APPLICATION NO.	FILING DATE	FIRST NAMED INVENTOR	ATTORNEY DOCKET NO.	CONFIRMATION NO.
10/597,424	07/25/2006	Rainer Garger	HRG-PT040 (G 596pct/us)	1795
3624	7590	04/01/2009		
VOLPE AND KOENIG, P.C. UNITED PLAZA, SUITE 1600 30 SOUTH 17TH STREET PHILADELPHIA, PA 19103			EXAMINER BENVENUTI II, MATTHEW GEORGE	
			ART UNIT	PAPER NUMBER
			3782	
			MAIL DATE	DELIVERY MODE
			04/01/2009	PAPER

Office Action Summary	Application No.	Applicant(s)	
	10/597,424	GARGER, RAINER	
	Examiner	Art Unit	
	Matt Benvenuti	3782

DETAILED ACTION

FIG. 4

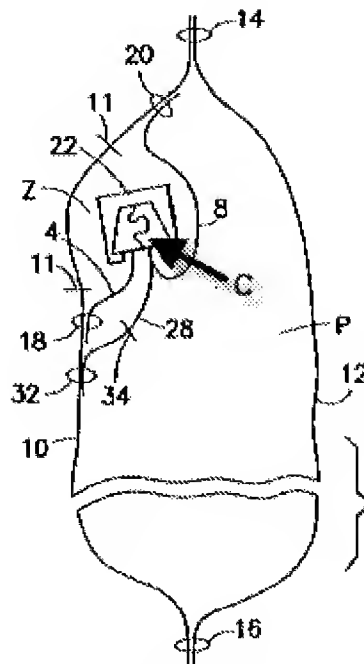
In re Claim 1, Schneider et al, Figure 4, teaches a re-sealable bag comprising a closure (C) attached in an interior thereof to one of the front or rear walls (10, 12), with the closure (C) comprising inner and outer closure parts (4, 28), which have edges at a distance from a connecting or latching area of the closure (C), the edges undetachably connected to the front or rear wall (10, 12), and having free edges that are connected undetachably to the wall (18, 32) and with a safety strip (the part of the front wall between 11 and 11) over an opening in the wall above the latching area of the closure (C), the safety strip (the part of the front wall between 11 and 11) is configured so that it can be separated from the wall before an initial opening of the bag for exposing the opening ([0033], Lines 10-13), both of the closure parts (4, 28) are connected to the wall (10) underneath the opening and a cover sheet (8) is attached to the inner closure part

(28) and also to the one of the front or rear walls (10, 12) above and to a side of the opening ([0032], Lines 8-13).

In re Claim 3, the combination further teaches a bag wherein a lower edge of the cover sheet is fixed undetachably at the inner closure part (Schneider et al, Figure 4, 8 attaches to 28)

In re Claim 4, the combination further teaches a bag wherein the lower edge of the cover sheet is fixed directly on or at a distance to an inner grooved closure (Schneider et al, Figure 4, 8 attaches to 28 at a distance to the inner grooved closure (C)).
